## **BROOKLYN'S WAY SUBDIVISION**

APPLICATION NUMBER 9 DATE October 2, 2003

APPLICANT Brooklyn's Way Subdivision

# DETAIL SITE PLAN

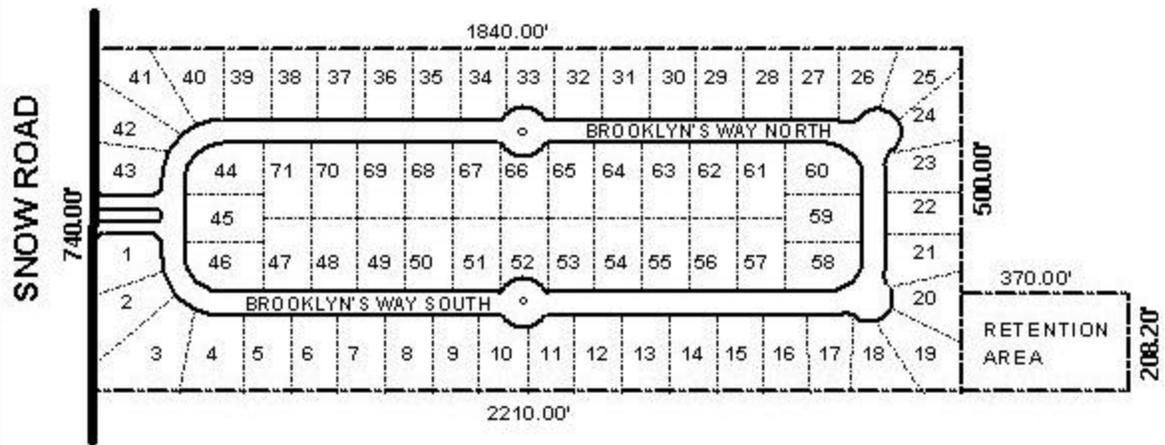
Snow Road, which has an existing right-of-way of 80-feet, is shown as a major street on the Major Street Plan, and as such requires a 100-foot right-of-way; therefore, the dedication of sufficient right-of-way to provide 50-feet from the centerline should be required. As illustrated on the site plan, the detention area would have access to a private road, thus a note on the final plat stating that access to the private road (Grimes Road) is denied, should be required.

The Subdivision Regulations state that a closed end street (cul-de-sac) shall not be longer than 600'. As proposed, the cul-de-sac is approximately 1,840' in length; thus, traffic calming devices should be required as illustrated on the plat. It should be noted that the large parcels to the South consist of a residence with a warehouse and a nursery thus a street stub would not be required.

As proposed, Lots 1 through 3 and Lots 41 through 43 would have frontage along Snow Road and the new street; therefore, the placement of a note on the final plat stating the Lots 1 through 3 and Lots 41 through 43 are denied direct access to Snow Road, should be required.

The detention area is not labeled as common area and thus a note stating that the detention area is labeled as common area and maintenance of the common area is the responsibility of the property owners, should be required on the final plat.

With modifications, the plat meets the minimum requirements of the Subdivision Regulations and is recommended for Tentative Approval subject to the following conditions: 1) the dedication of sufficient right-of-way to provide 50-feet from the centerline of Snow Road; 2) the placement of a note on the final plat stating the access is denied to the private road (Grimes Road); 3) the placement of a note on the final plat stating the Lots 1 through 3 and Lots 41 through 43 are denied direct access to Snow Road; 4) the placement of a note on the final plat stating maintenance of all common areas is the responsibility of the property owners; 5) the placement of a note on the final plat stating that any property developed commercially and adjoining residentially developed property will provide a buffer in compliance with Section V.A.7. of the Subdivision Regulations.
